STATE OF WASHINGTON
DEPARTMENT OF ECOLOGY

March 19, 2021

Re: Ecology Comments on Draft Remedial Investigation Work Plan
Texaco 211577 Monterey
631 Queen Anne Avenue N, Seattle, WA 98109
Facility Site No.: 77774779
Cleanup site ID No.: 6663

Figure 1 2008 Soil Vapor Probe Locations on Del Roy Apartment

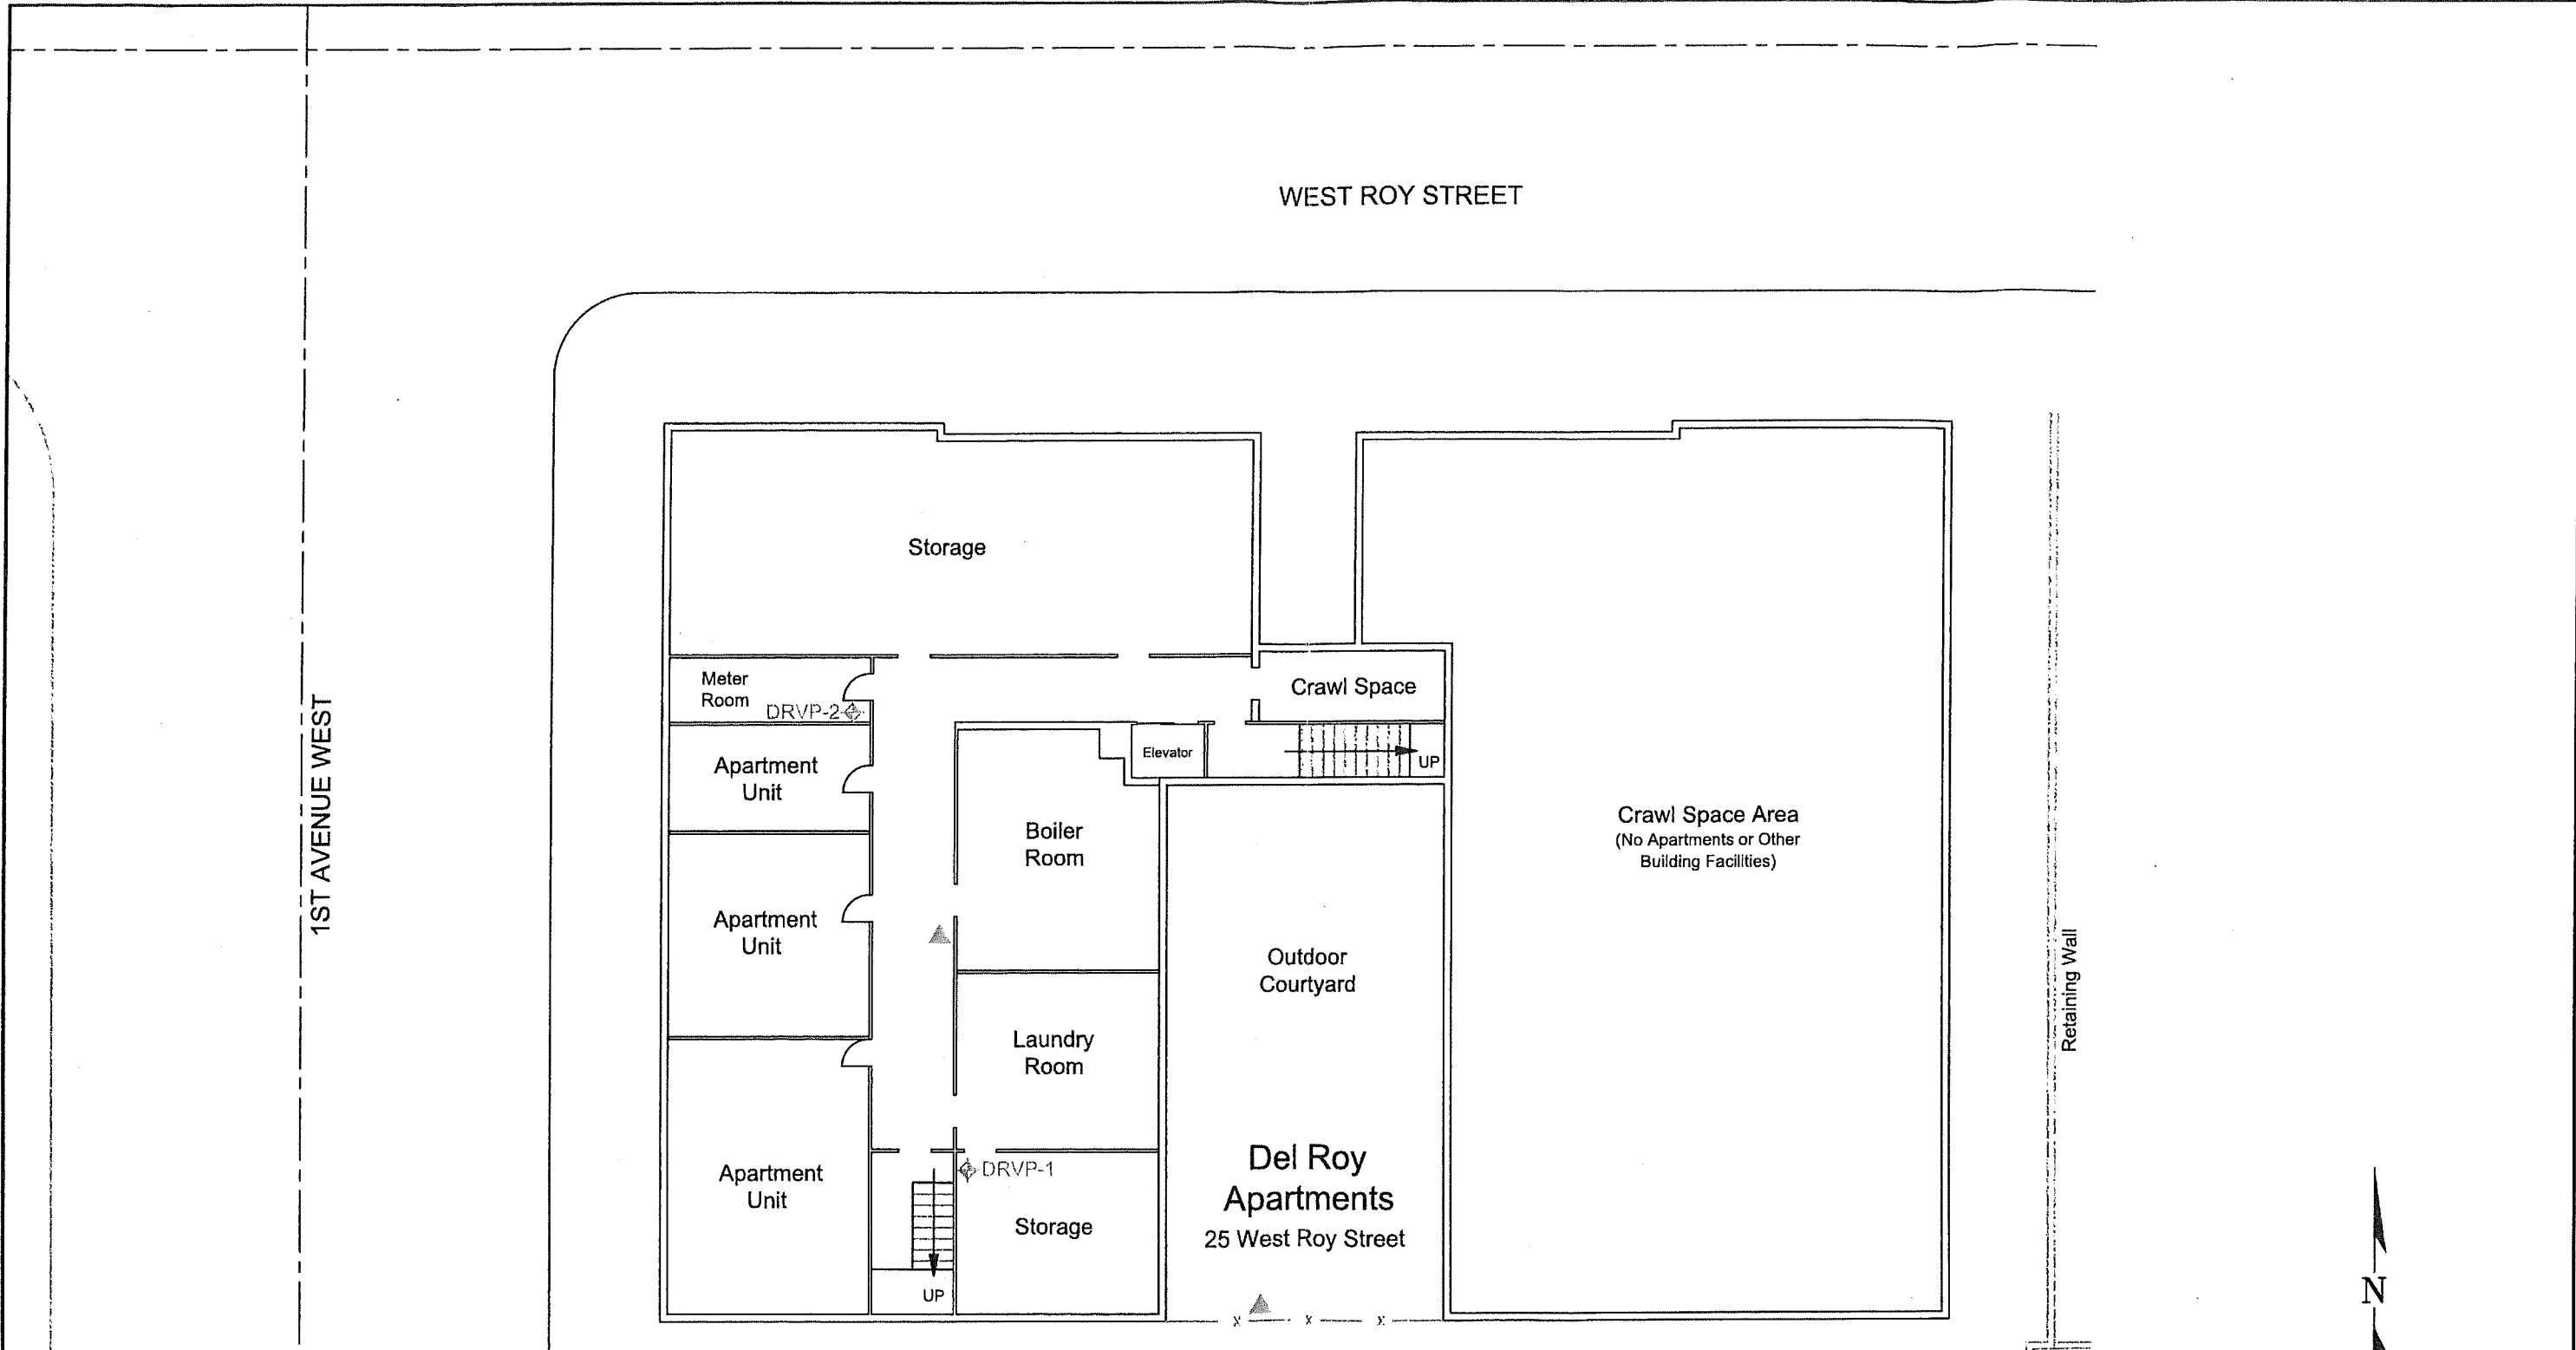
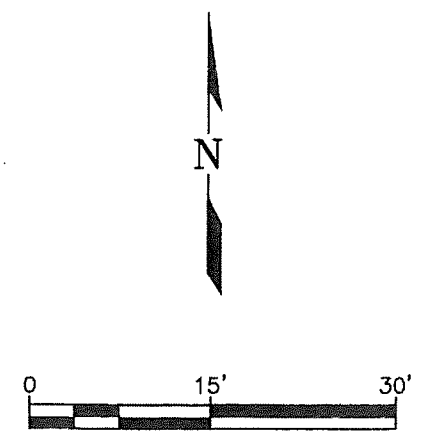
- In 2008, two soil vapor probes (DRVP-1 and DRVP-2) were installed immediately below the basement (sub-slab) of the Del Roy Apartments building (**Figure 1**); one vapor probe

- Ecology requires assessment of the locations and current status of the previously installed soil vapor probes DVP-1, DVP-2, DRVP-1, and DRVP-2, and MVP-1. If these soil vapor probes cannot be used for sampling, Ecology requires installation of at least two soil vapor probes under each of the Del Roy and Monterey Apartments building. Soil gas samples shall be collected from the soil vapor probes beneath the Del Roy and Monterey Apartments buildings.

Figure 2 2008 Soil Vapor Probe Locations on Monterey Apartment

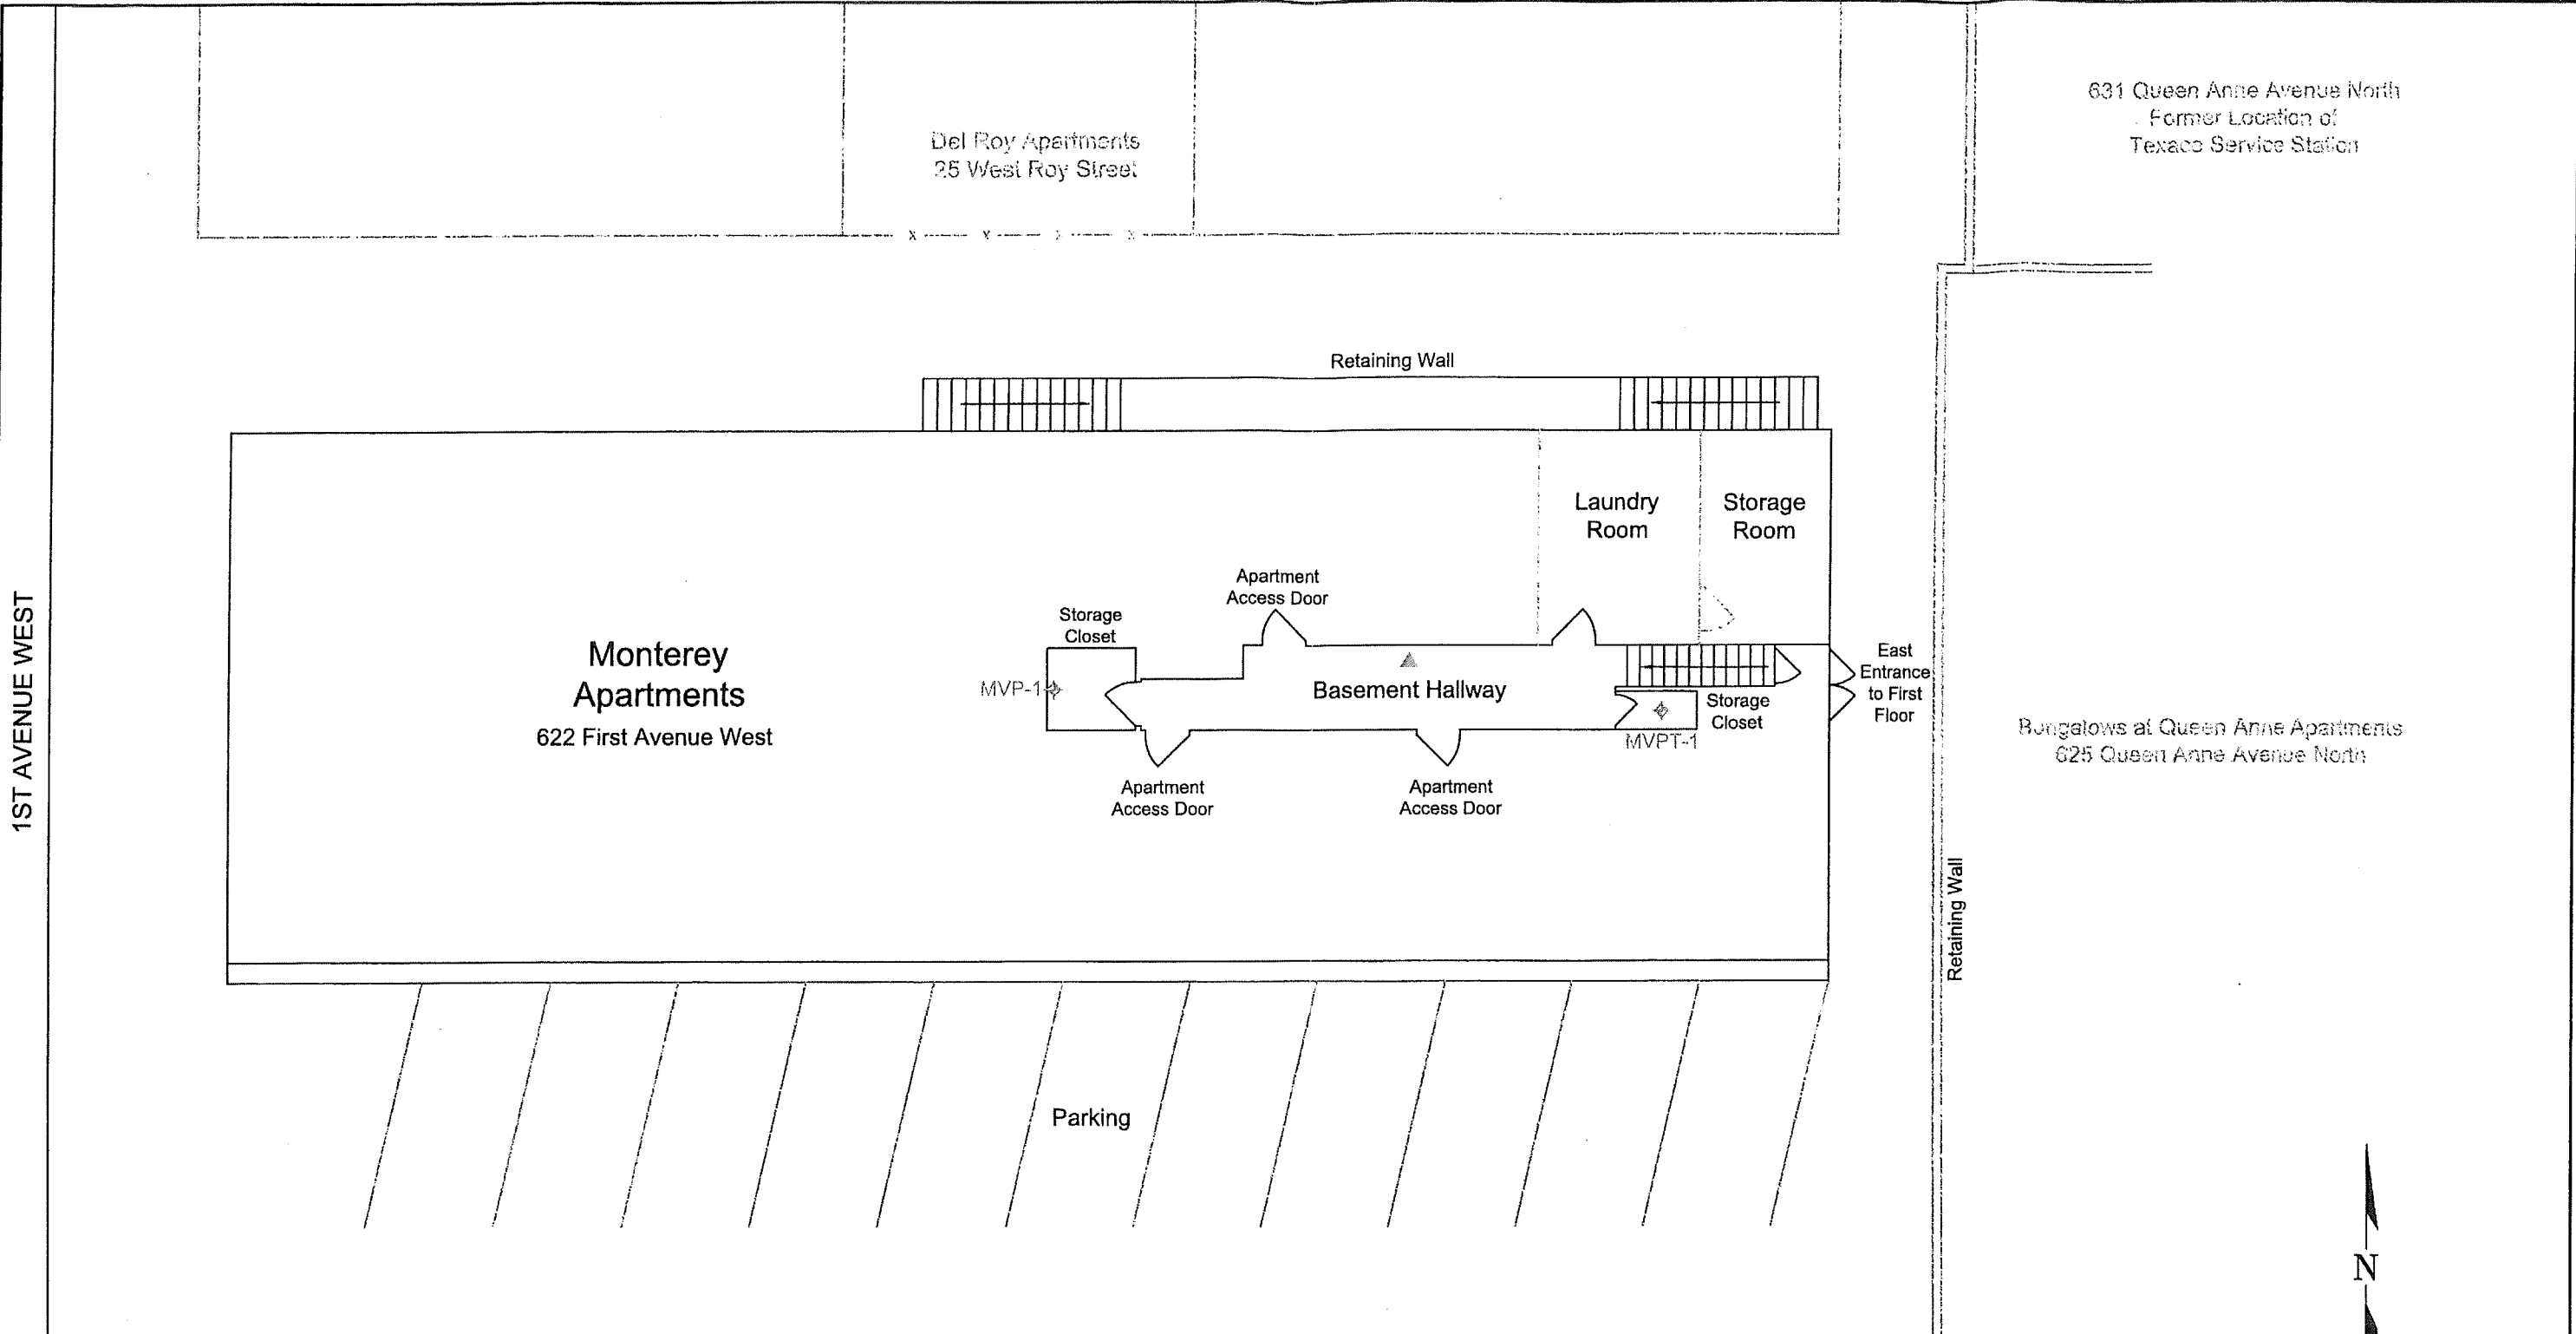
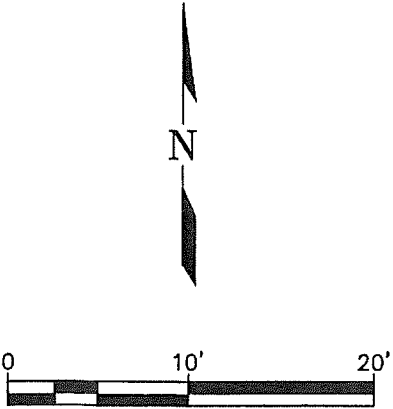
(MVP-1) and one temporary vapor probe (MVPT-1) were installed sub-slab in the basement of Monterey Apartments building (**Figure 2**)⁷.
